VSP-33
December 18, 1981

VENDOR SERVICE PUBLICATION

To: All Piper Distributors and CORPAC's
Subject: Bendix Service Bulletins 611, 616, 617, 619

Figure 1. Location of Drain Holes

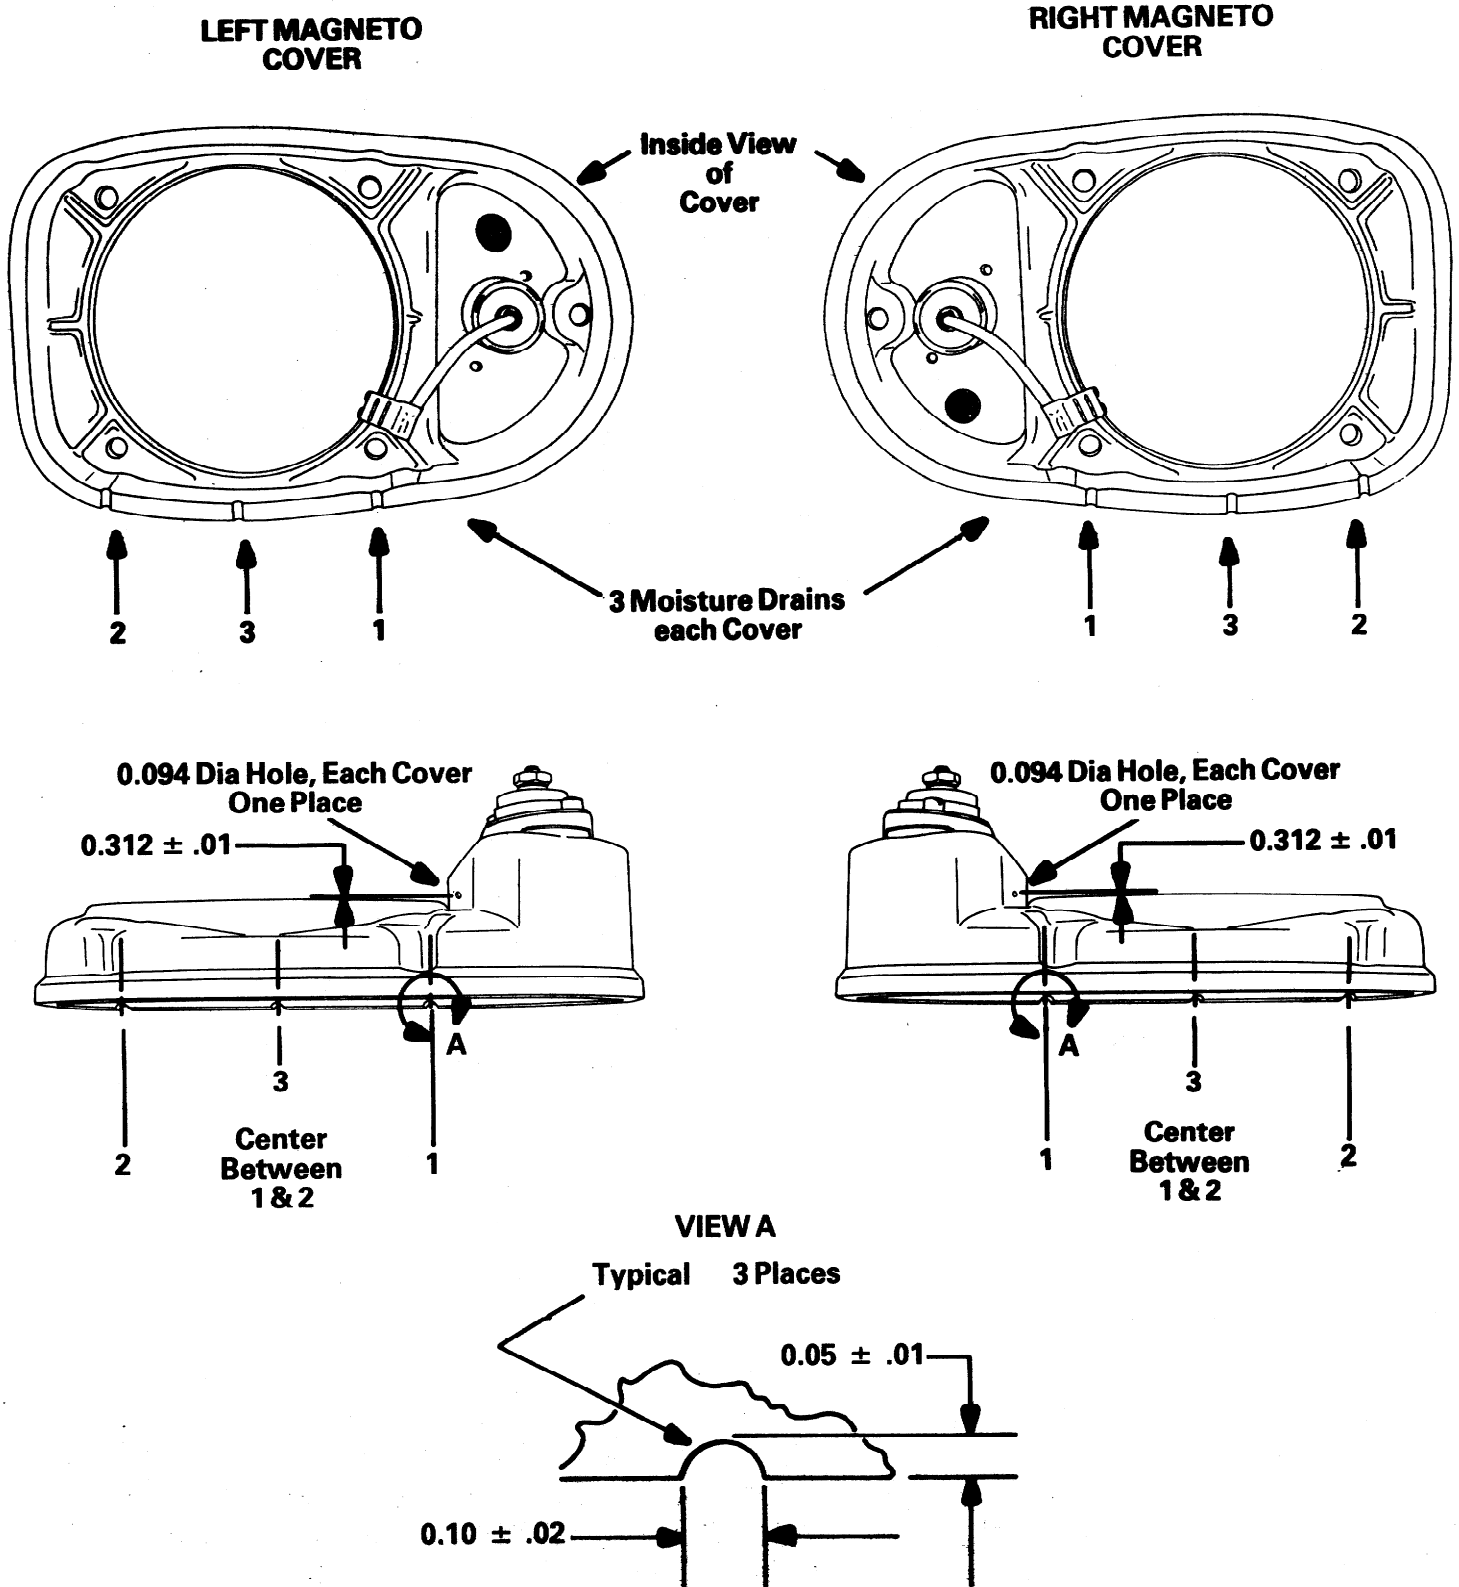
1. Remove the magneto cover by removing the ignition harness adapter plate from each magneto and then removing the magneto cover securing screw. Pull the magneto cover away from the magneto and carefully pull the capacitor, and retard lead, if used, from the breaker flag terminal(s).
2. Using Figure 1 as a guide, lay out the positions for the moisture drains. Positions 1 and 2 are in line with the stud holes in the cover and position 3 is centered between 1 and 2. Using a small round file, create the three hemispherical recesses as detailed in view A, figure 1.

The moisture drains must be on the lower side of each cover when it is reinstalled on its related magneto assembly on the engine.

3. Lay out the position for drilling a 0.094 in. \pm 0.005 in. hole in the center of the ledge area of the covers and drill one hole in each cover using a 3/32" or No. 42 drill, as shown in Figure 1.

Do not allow the drill to penetrate through the cover and hit the housing of the capacitor which is directly in line with the hole being drilled. Mask drill bit for maximum allowable depth (1/4 in.).

Figure 1. Exploded View

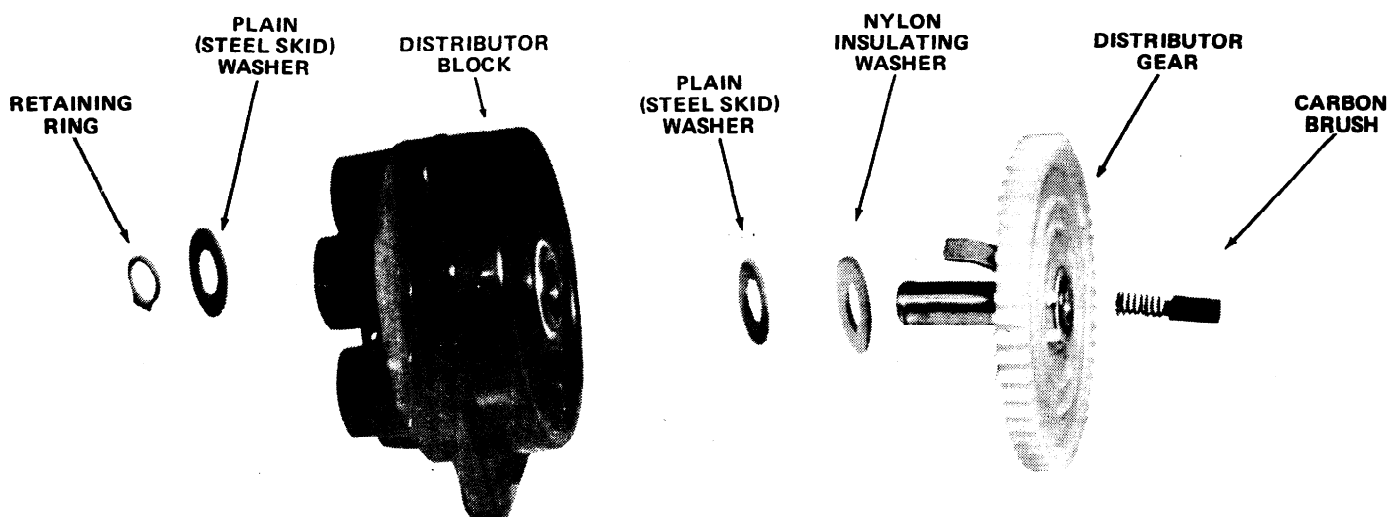
The 10-357584 and 10-357586 Insulated Distributor Gear Kits for S-20 and S-200 Series Magnetos are being provided as a standardization change for Bendix magnetos. With the introduction of these kits, all new Bendix aircraft magnetos delivered from the factory will be provided with insulated distributor gears. The insulated gear kits include all parts (except distributor block) as identified in figure 1.

Assembly sequence of the gear kit to distributor block is shown in the exploded view of figure 1.

Figure 1. Location of "x" on Identification Plate

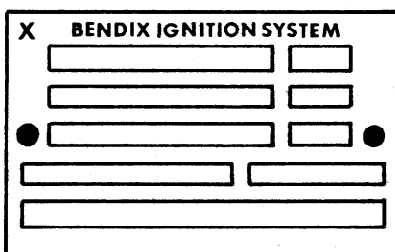
All D-2000/2200 series magnetos below serial number 35480 (red label magnetos) and below serial number 8122106 (blue label magnetos) unless identified with an "x" in the upper left corner of the identification plate before the word "Bendix" (see figure 1). The "x" on the identification plate indicates previous compliance.

6. If new serviceable gears, identified with the "z", the "x" and "o", or the "L" are installed in the magneto, identify the magneto by stamping the letter "x" in the upper left corner of the identification plate, before the word "Bendix" (see figure 1).

Figure 2. Location of Identification Mark(s)
on Distributor Gear

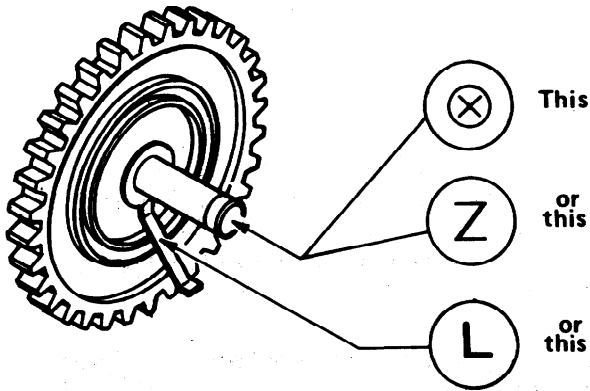
hours or at the next regularly scheduled inspection, whichever occurs first, and reinspected every 100 operating hours until the magneto has 500 operating hours. If the gears fail the inspection they must be replaced immediately with new, serviceable gears; if they pass each inspection they may remain in service until magneto overhaul, at which time they must be replaced with new, serviceable gears. At owner's option, gears that pass inspection may be replaced at any time during the compliance period with new, serviceable gears as identified in this paragraph and figure 2. Serviceable gears are identified by the presence of the letter "z" or the letters "x" and "o" appearing together, laser etched on the retaining ring end of the gear axle, or the letter "L" stamped on the electrode (see figure 2).

Figure 3. Checking for Loose Electrode

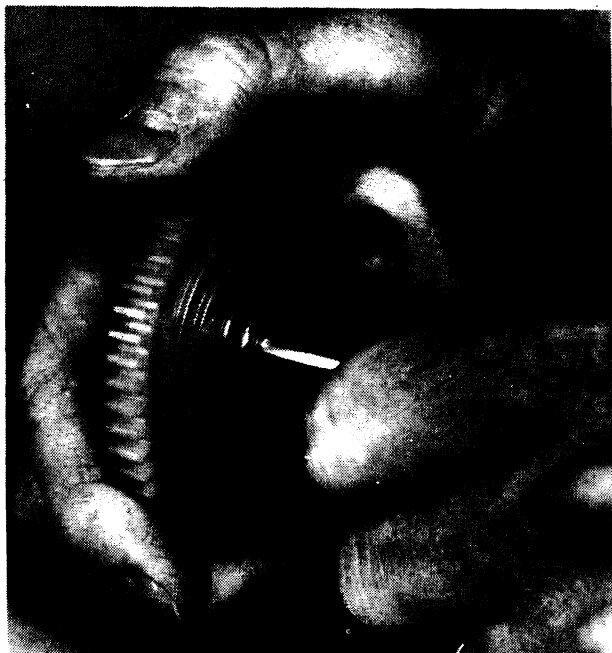
5. If the gear is the uninsulated type (no nylon washer) inspect the gear for a loose electrode. Grasp the gear firmly in one hand and alternately exert clockwise and counterclockwise force against the electrode with maximum hand pressure. This should be done in a manner that would attempt to pivot the electrode around the axle (see figure 3). If any movement is detected between the electrode and the gear, the gear must be discarded and replaced with a new, serviceable gear.

Figure 1. Location of "x" on Identification Plate

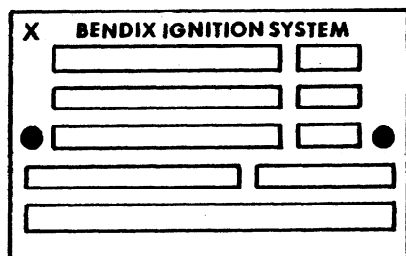
All D-3000/3200 Series (blue) Magnetos with Serial Numbers 100 through 1968 not identified by the letter "x" in the upper left corner of the identification plate (see figure 1). The "x" on the identification plate indicates previous compliance.

7. After the magneto has been reassembled with new serviceable gears, identify the magneto by stamping the letter "x" in the upper left corner of the identification plate, before the word "Bendix" (see figure 1).

Figure 2. Location of Identification Mark(s)
on Distributor Gear

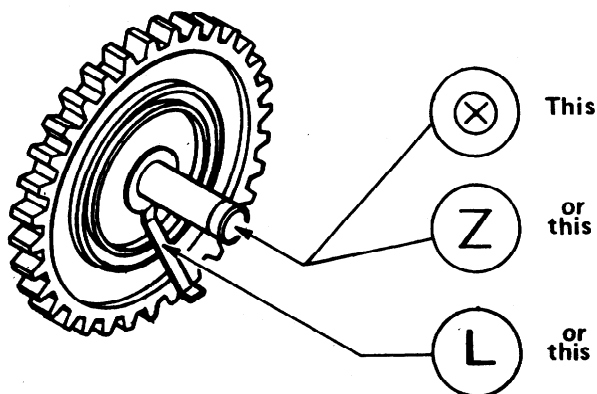
All distributor gear kits P/N 10-682014 and P/N 10-682016 which contain gears that are not identified by the presence of the letter "z" or the letters "x" and "o" together, laser etched on the retaining ring end of the gear axle, or the letter "L" stamped on the electrode (see figure 2).

5. Reassemble the distributor block with new serviceable gears. Serviceable gears are identified by the presence of the letter "z" or the letters "x" and "o" together, laser etched on the retaining ring end of the gear axle, or the letter "L" stamped on the electrode (see figure 2).
